SUBJECT: RESOLUTION OF MULTIPLANT ACTION NO. B-48, ADEQUACY OF STATION
ELECTRIC DISTRIBUTION VOLTAGE

Re: Quad Cities Nuclear Power Station, Units 1 and 2

SAFETY EVALUATION
QUAD CITIES STATION UNITS 1 AND 2
DOCKET NOS. 50-254 AND 50-265
ADEQUACY OF STATION ELECTRIC DISTRIBUTION SYSTEM VOLTAGES

ADEQUACY OF STATION ELECTRIC DISTRIBUTION SYSTEM
VOLTAGES, QUAD CITIES STATION, UNIT NOS. 1 AND 2

Figure 1. Quad Cities Station, Unit One Line Diagram.

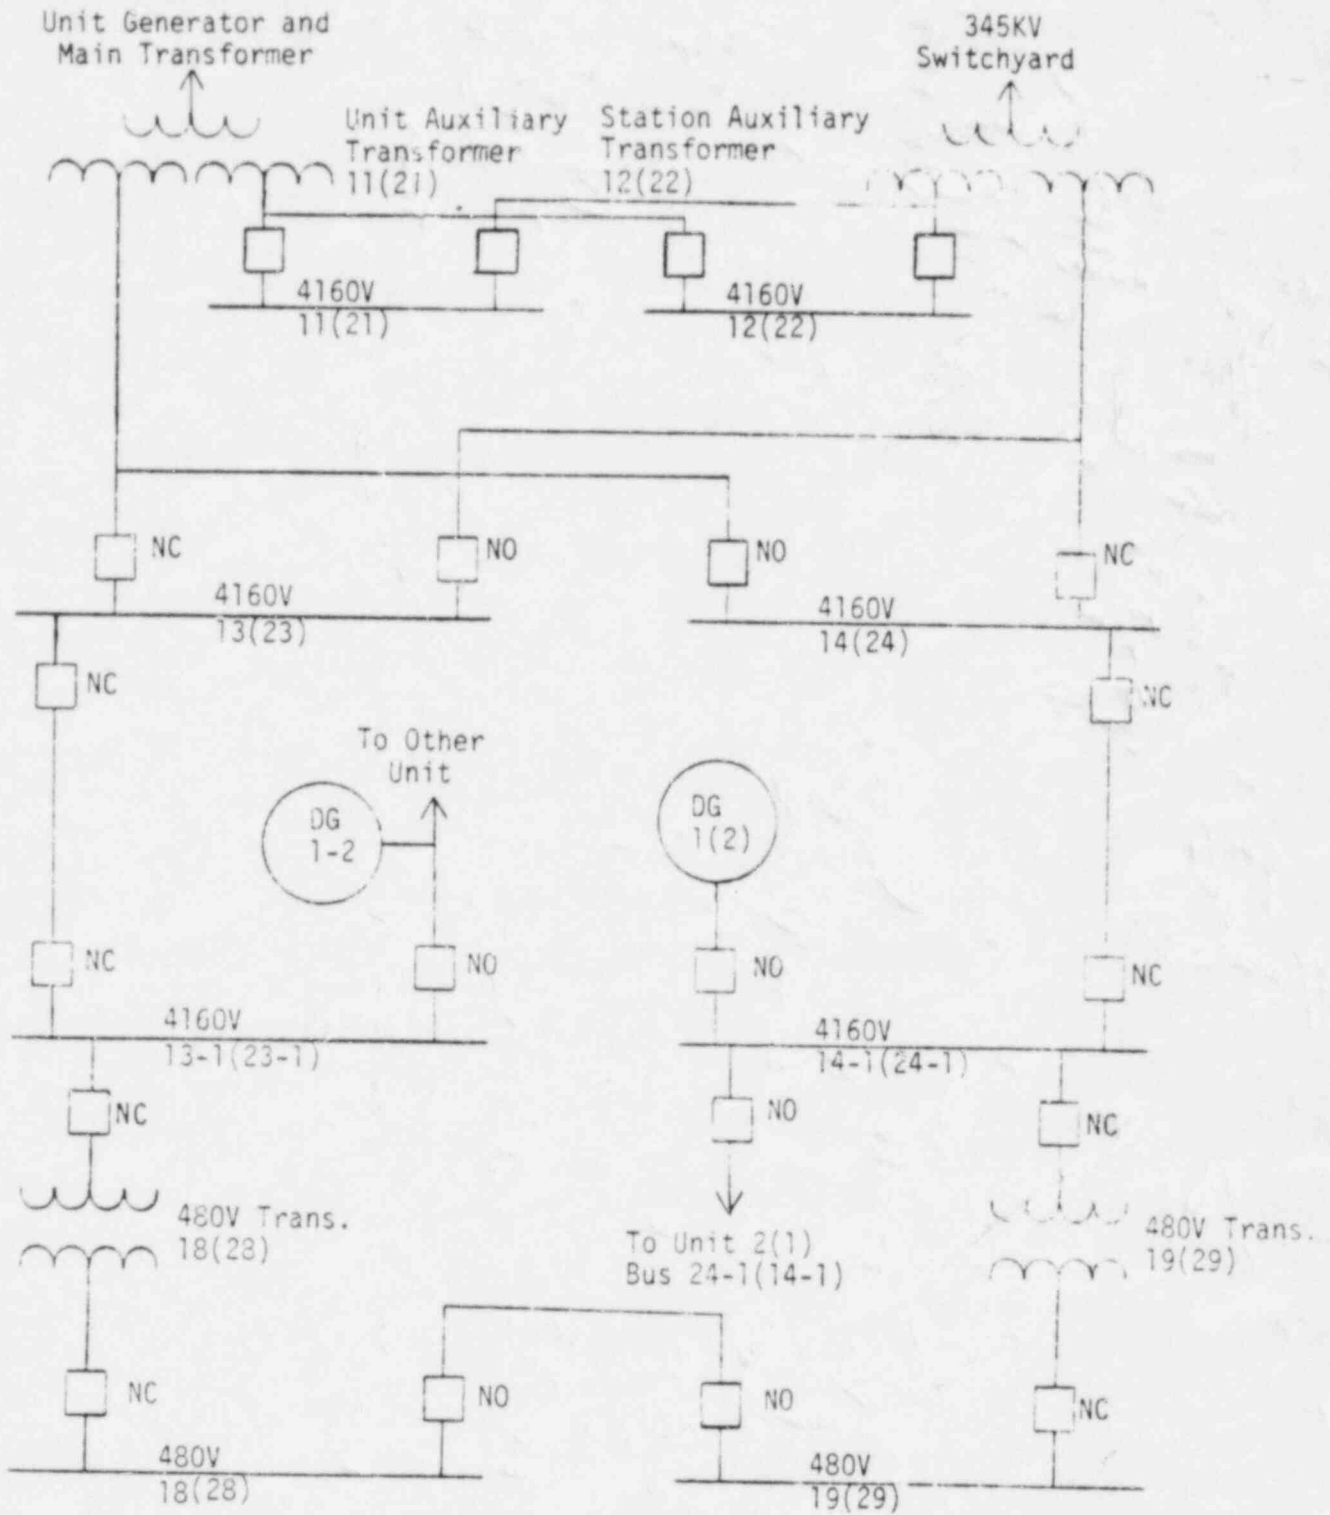
Figure 1 of this report is a simplified sketch of the unit one-line diagram taken from the Sargent & Lundy report². Figure 1 shows that, for Unit 1, the Class 1E 4160V buses 13-1 and 14-1 are normally supplied power from auxiliary buses 13 and 14, respectively. With loss of the unit generator, these buses are supplied by the station auxiliary transformer (SAT)^a from the 345kV switchyard. Class 1E 4160V bus 14-1 can be supplied power from the other unit via a manual connection^b to Class 1E bus 24-1 of Unit 2. This inter-tie can also be used in the other direction to energize bus 24-1 of Unit 2 from the Unit 1 SAT. The Unit 2 distribution system is identified as similar in the FSAR, except for different bus and transformer numbers.

Each 4160V Class 1E bus supplies power for one 480V Class 1E bus via independent transformers (4055/480V tap). These 480V buses can be connected together without technical specification restrictions; however, each Class 1E 480V bus has an undervoltage alarm.¹²
